**LEBANON PLANNING BOARD
JUNE 8, 2026 - 6:30 PM
COUNCIL CHAMBERS, CITY HALL OR
REMOTE VIA VIRTUAL PLATFORM
LEBANONNH.GOV/LIVE**

RE: June 8, 2026 Regular Meeting - Agenda Item 3.B
Site Plan Application for 63 Evans Drive (Tax Map 78, Lot 40-100)

From: Tim Corwin
Sent: Thursday, May 14, 2026 9:16 PM
To: Dan Nash; 'Johanna Cicotte'
Cc: Brian Vincent; Crystal Taplin; Nathan Reichert
Subject: 63 Evans Dr_PB2026-28-SPA_Staff Comments
Attachments: 2000 Site Plan NOAs and Approved Plan Set.pdf

PLANNING STAFF COMMENTS (PB2026-28-SPA) (please note that (a) parenthetical references are to Section numbers of the Lebanon Site Plan Review Regulations, and (b) comments are arranged in general categories, i.e. the order of comments is not intended to denote importance)

L-1

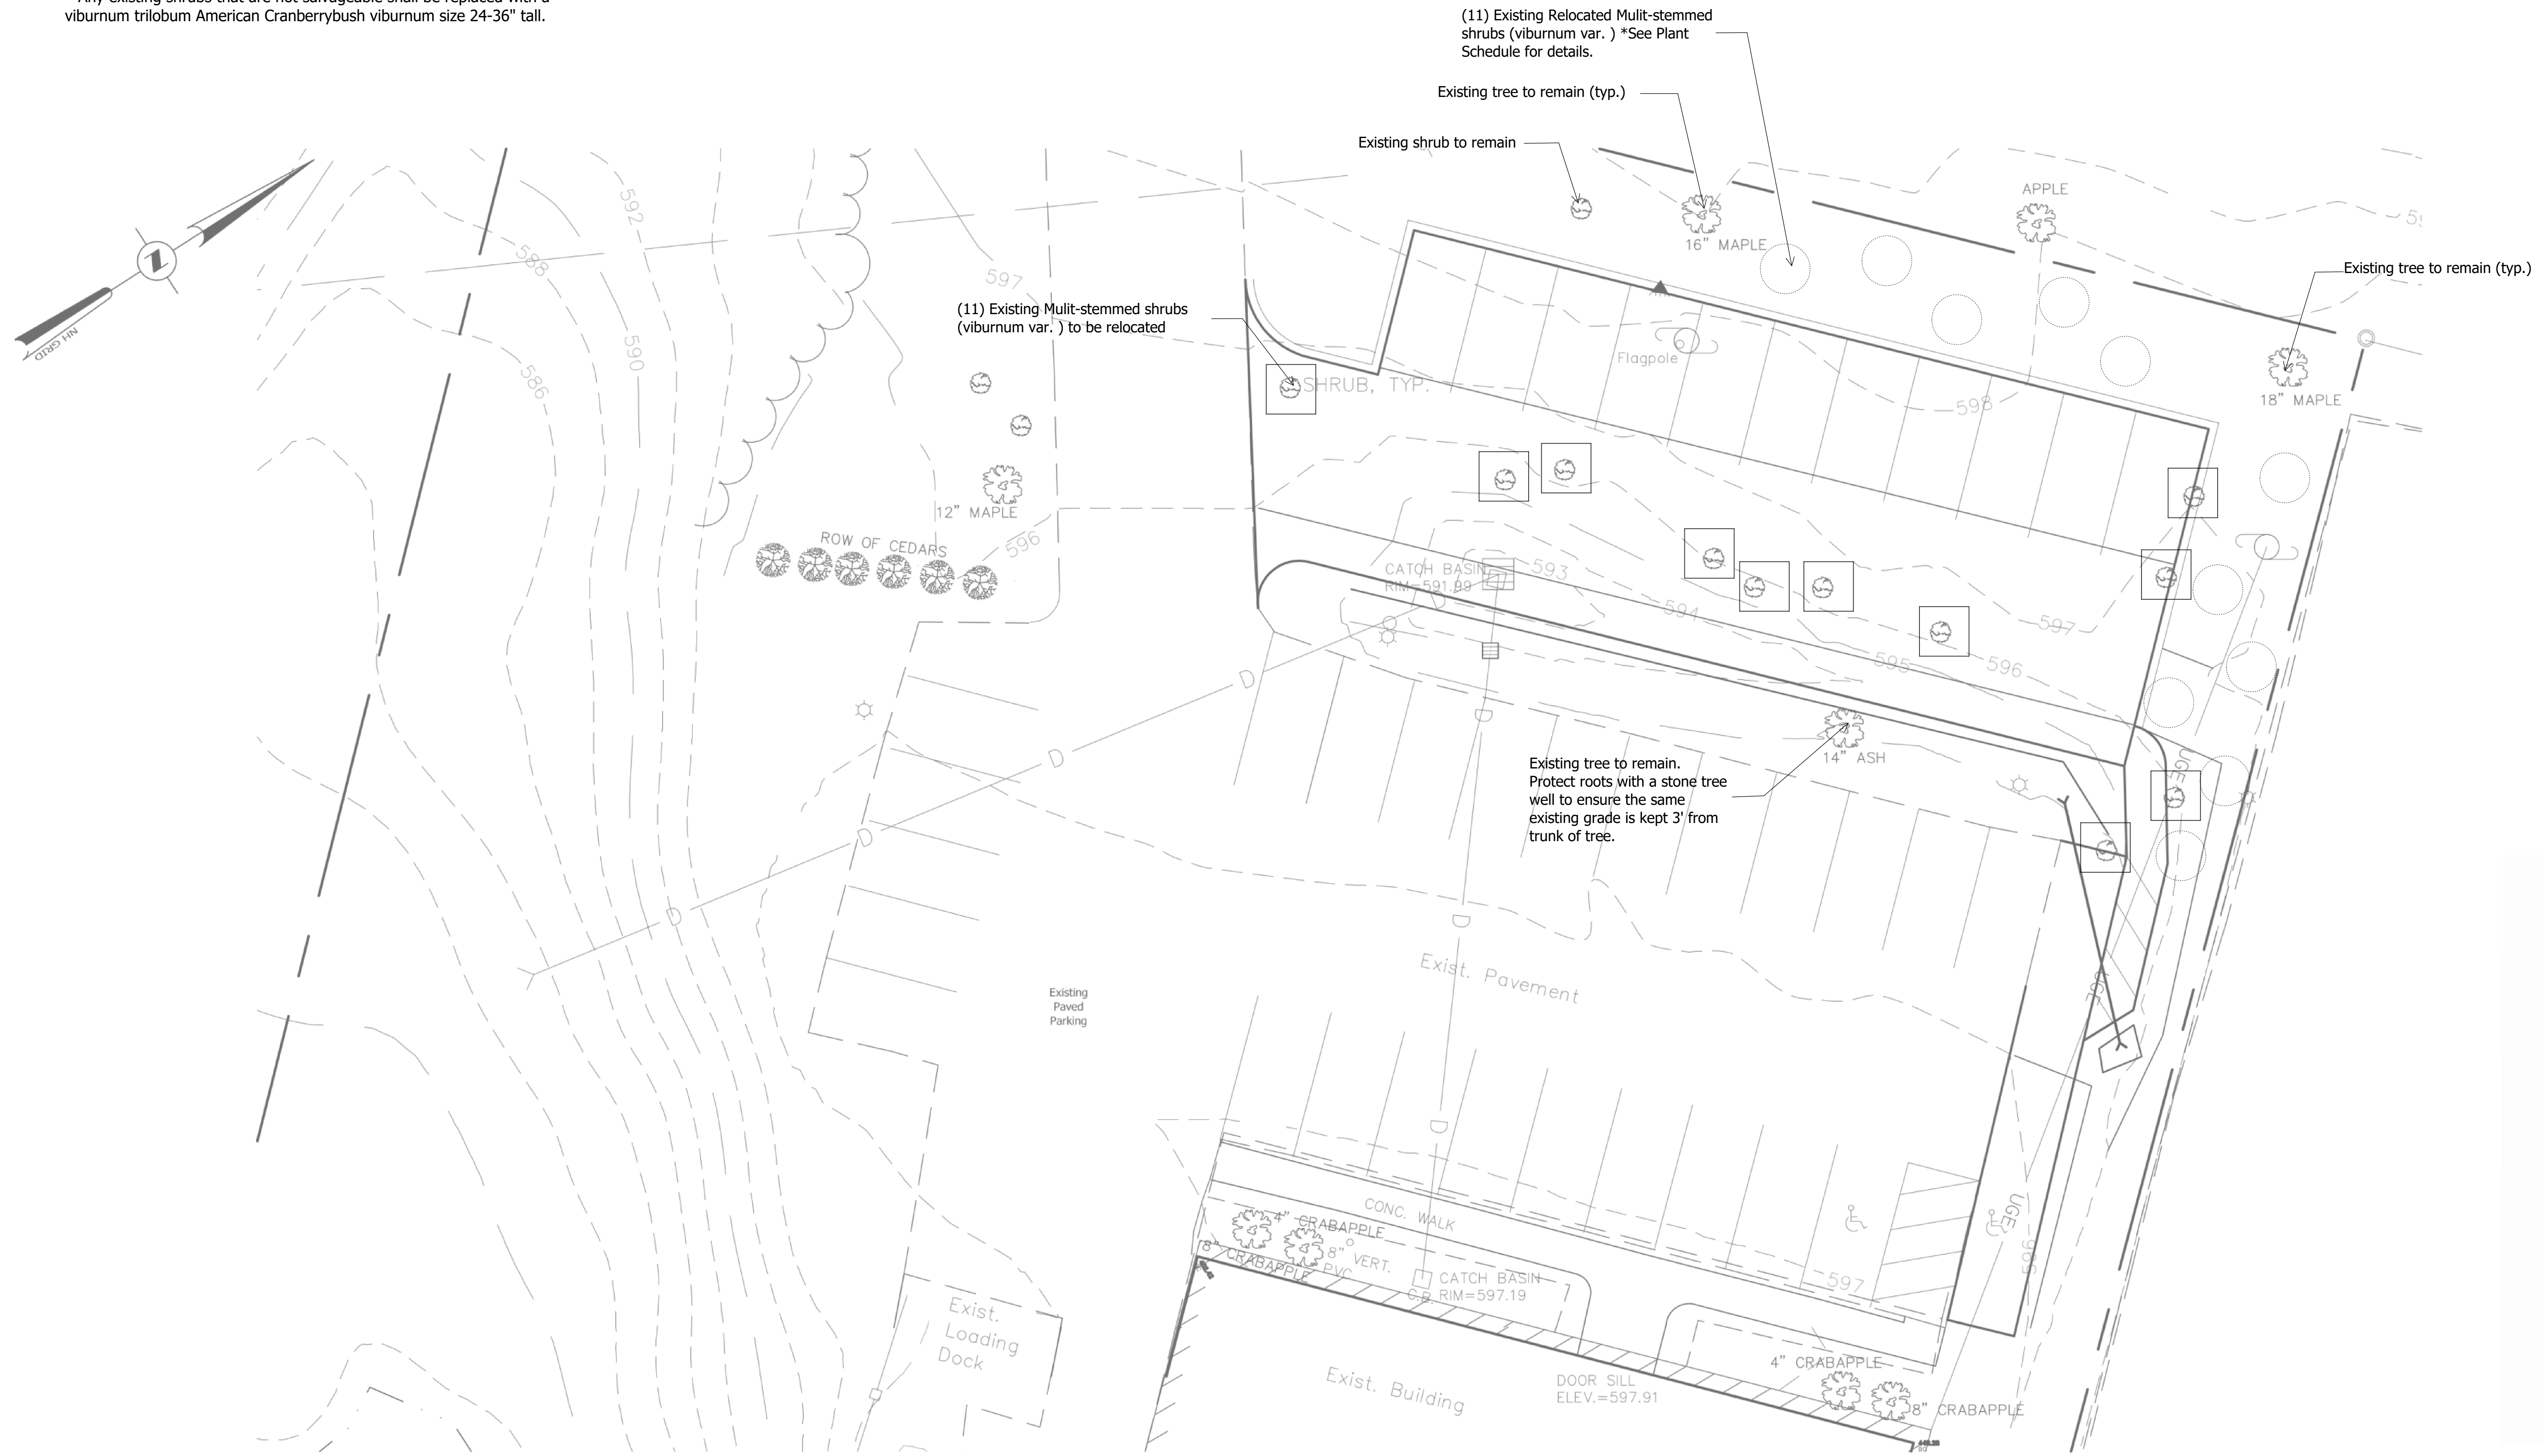
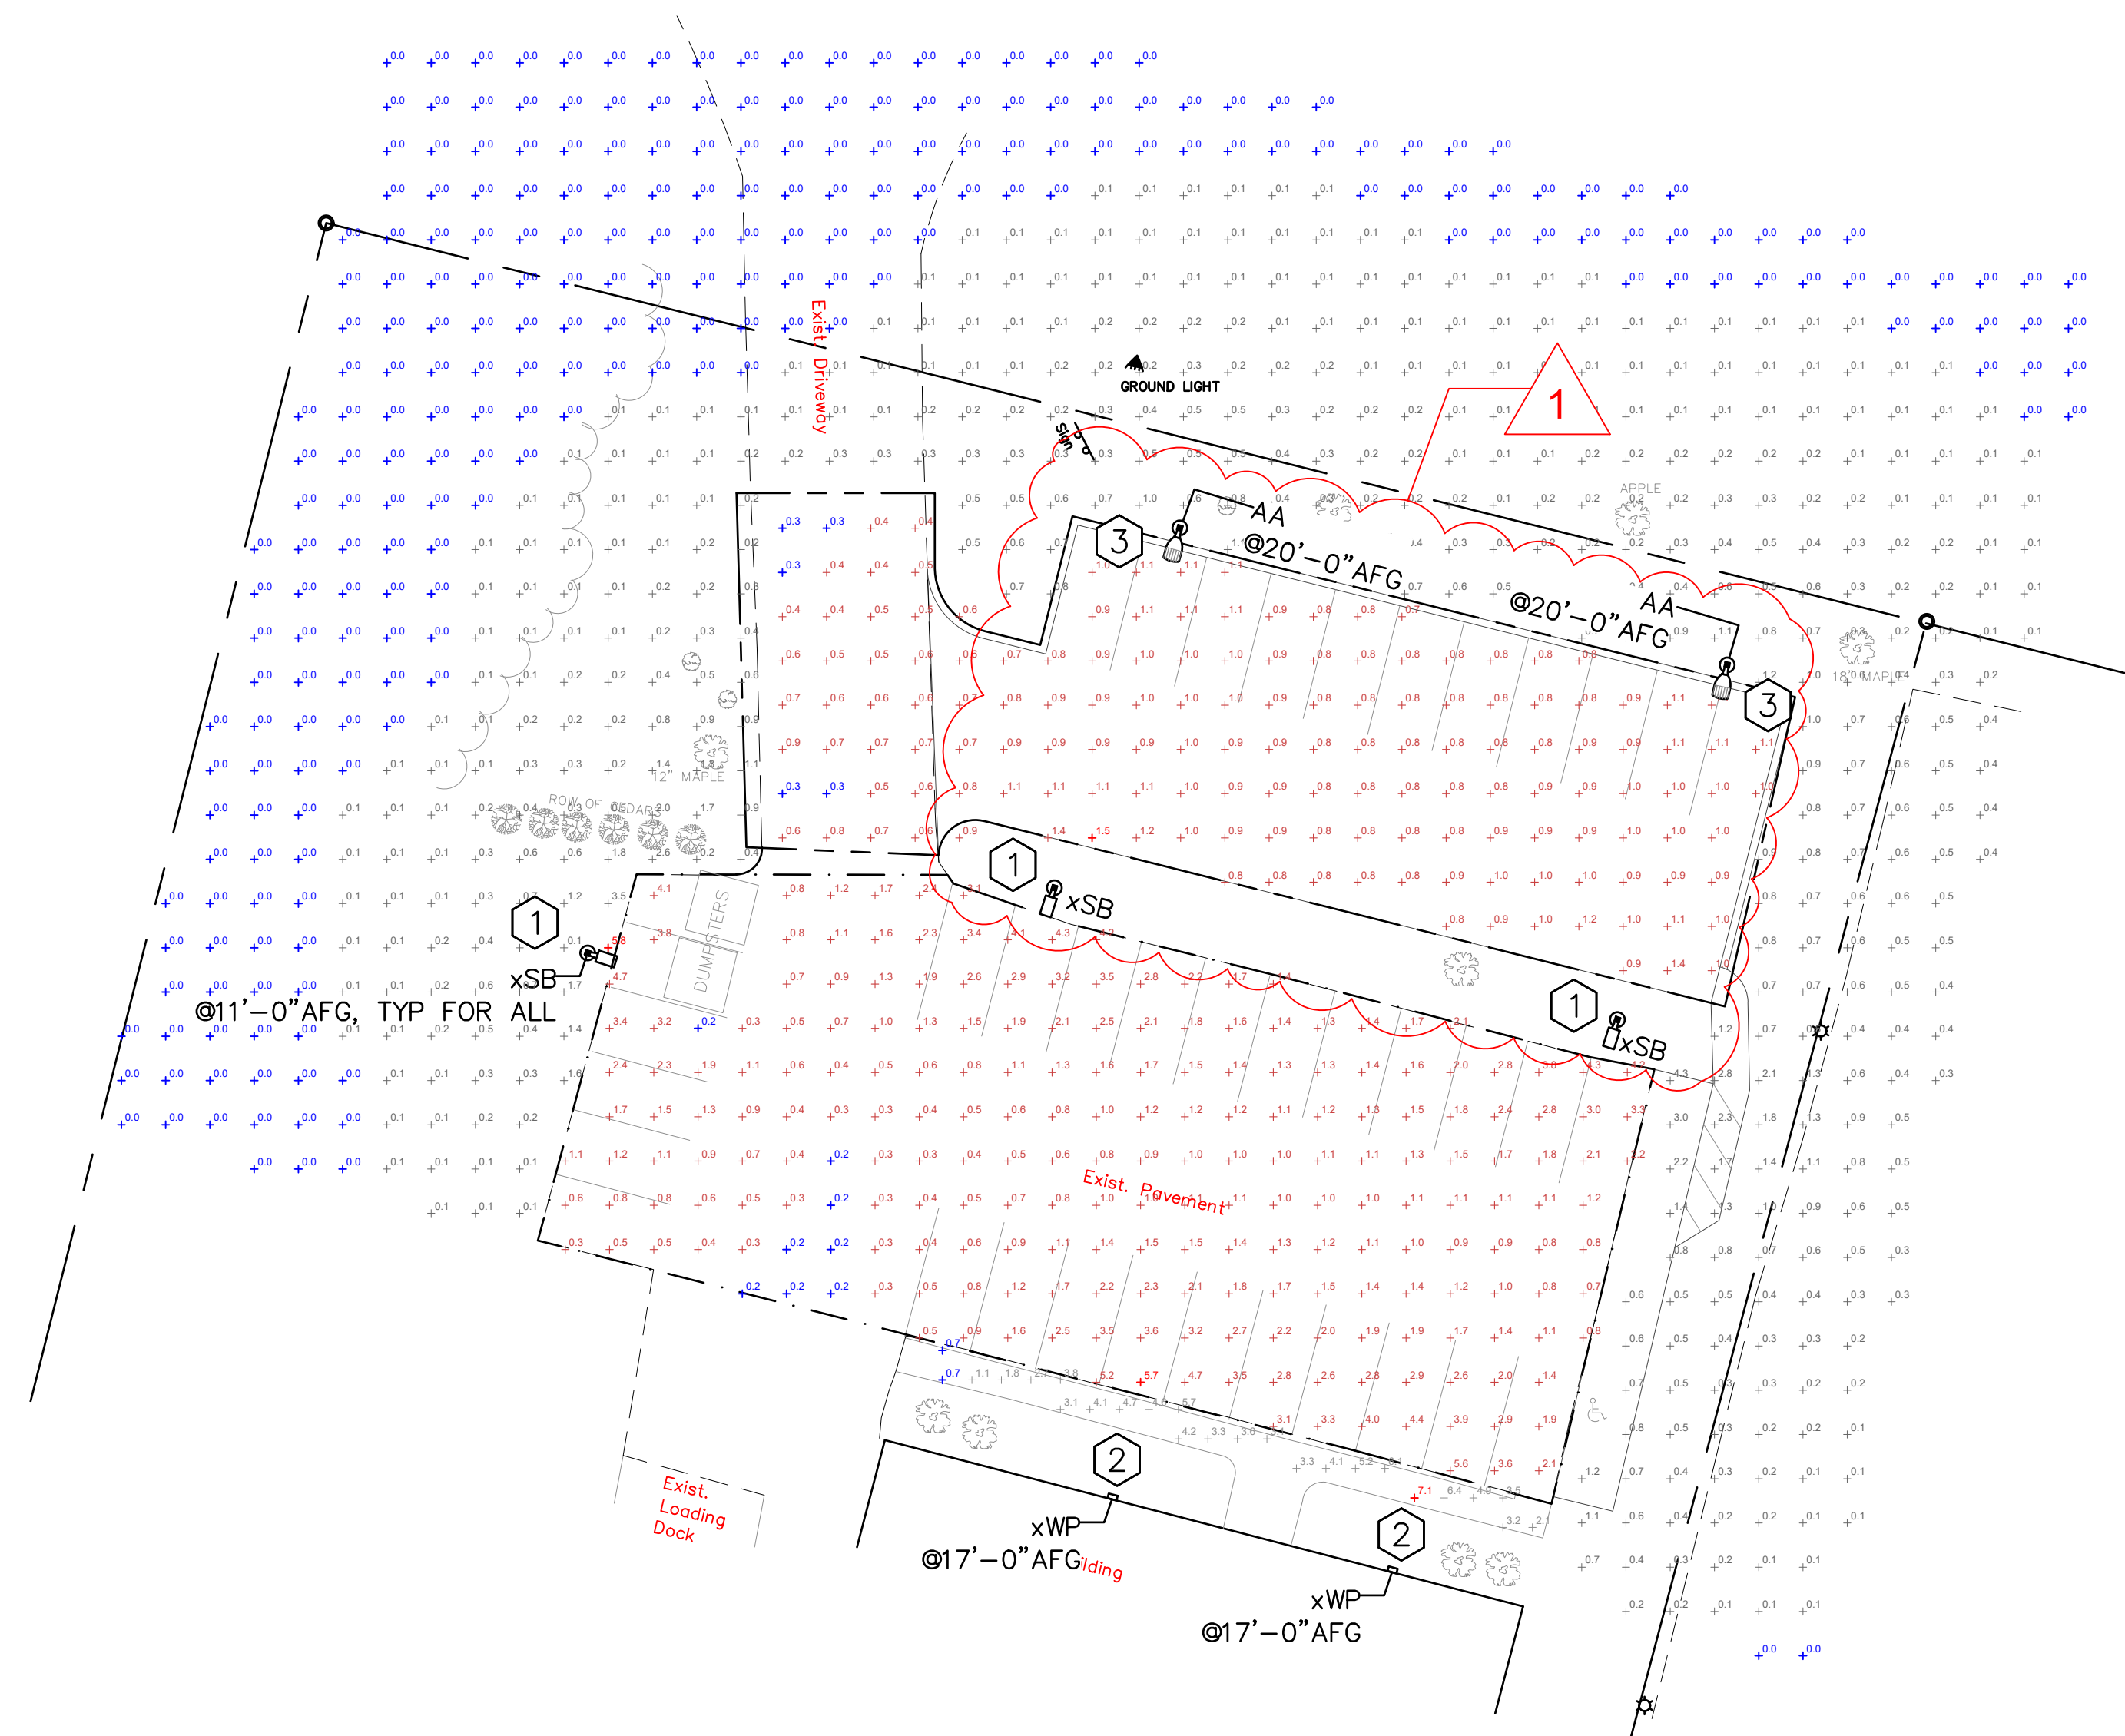
36. The plan does not meet the Section 6.2.B perimeter landscaping and Section 6.2.E parking area landscaping requirements.
37. The plan proposes to relocate existing plantings to areas that, according to the landscaping plan, are currently unvegetated. However, these areas should already be landscaped in accordance with the approved site plan. Clarification is needed.
38. The plat is very difficult to read. Remove unnecessary layers including existing conditions, and provide additional labels to identify what's proposed.
39. Overall, the landscaping plan is substantially unintelligible and the proposed improvements/site layout cannot be reasonably discerned, especially for the area located between the existing and proposed parking areas:

LIGHTING PLAN

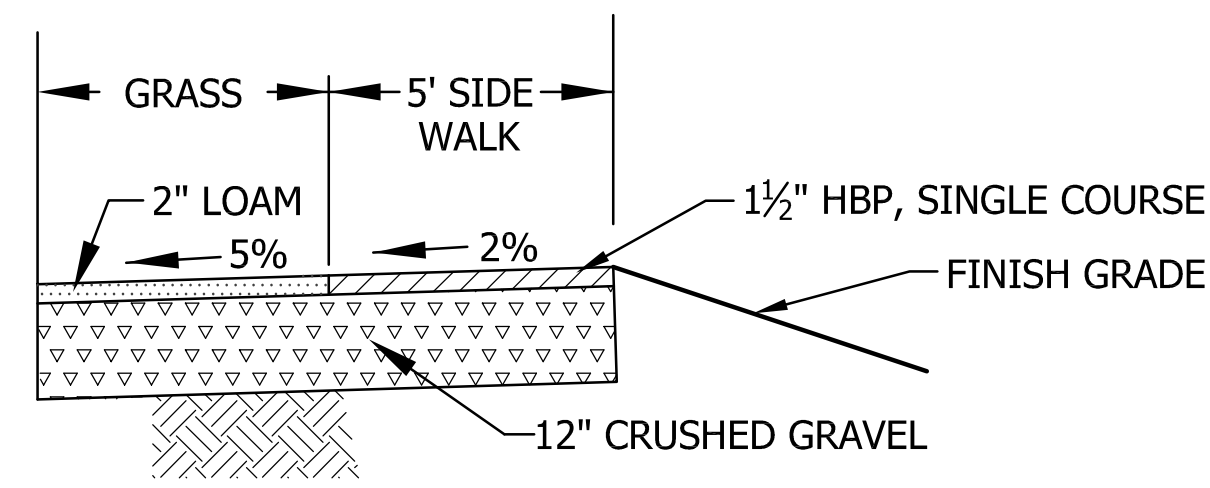
- 40. Remove all notations indicating changes to the plan set (it's not possible for the plan to have changes since it has never been reviewed by staff or the Planning Board).
- 41. Note 1: what is the "City of Lebanon Model Lighting Ordinance"? Only two of the "existing" units shown on the second floor are legal. Please add a note to this effect or change the two unpermitted units from "existing" to "proposed".
